P 515302-D

ON-SITE SEWAGE DISPOSAL SYSTEM HOWARD COUNTY HEALTH DEPARTMENT BUREAU OF ENVIRONMENTAL HEALTH

SUBDIVISION: Hong Property LOT NUMBER: 4

ADDRESS: 15814 Old Frederick Road PROPERTY OWNER: Altieri Enterprises

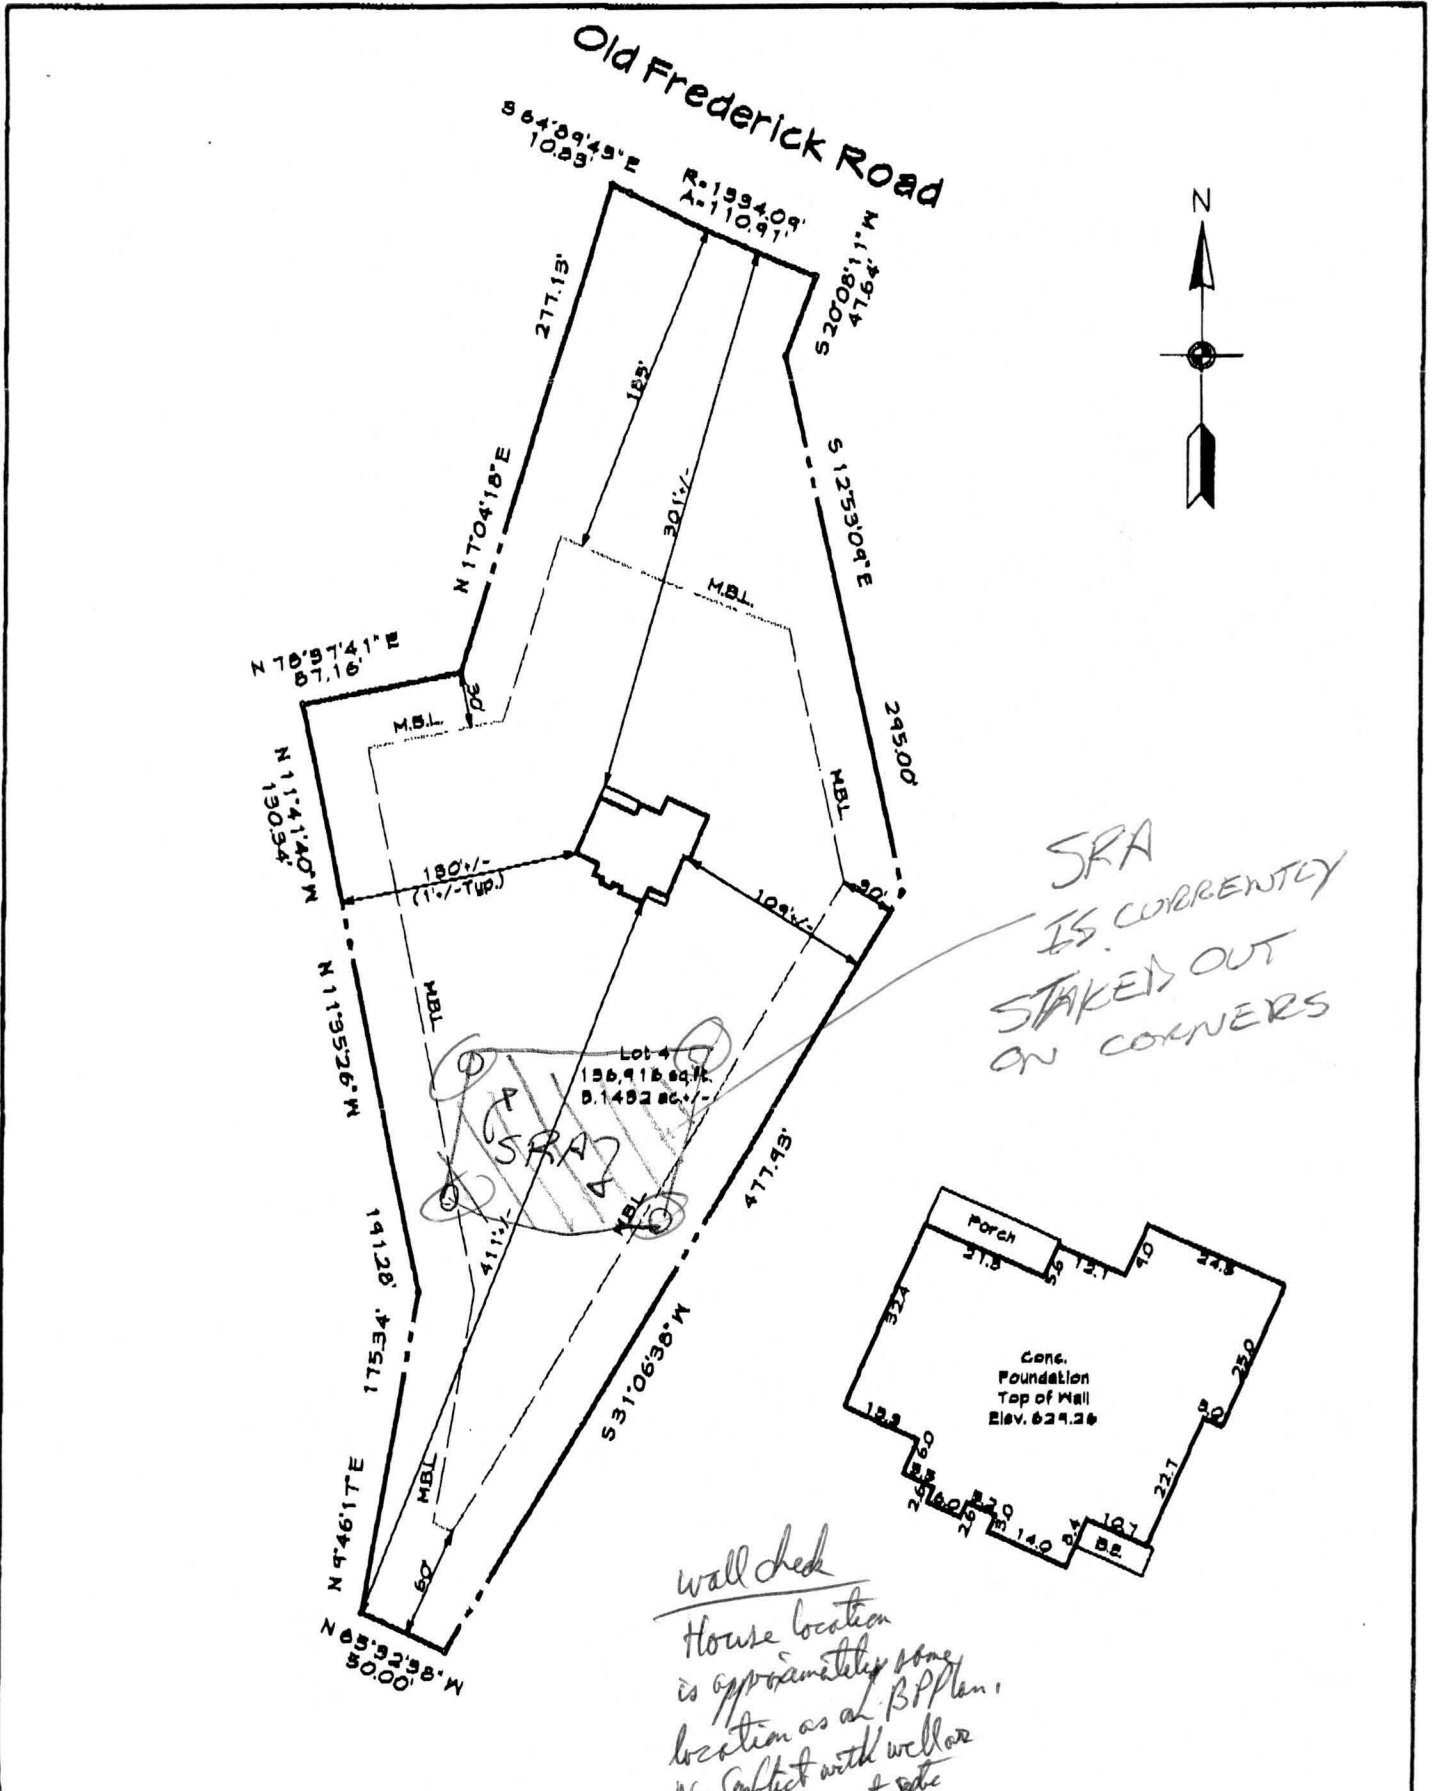
PRE-CONSTRUCTION INSPECTION: 7/10/01 Went over layout with builder. To

install as per B.P. plan. (BB)

INSPECTION COMMENTS: 7/17/01- UPPER RT. CORNER OF SDA UNUSABLE DUE TO
CONTOUR, INSTALL TRENCHES ON CONTOUR W/ BOTTOMS AT 6.5' - (SRK)

7/19/01-SYSTEM OK PENDING HOUSE CONNECTION - (SRK)

9/27/01- HOUSE CONN. VERIFIED TO HAVE BEEN MADE DURING T/C W/ RUSTY (BUILDER)
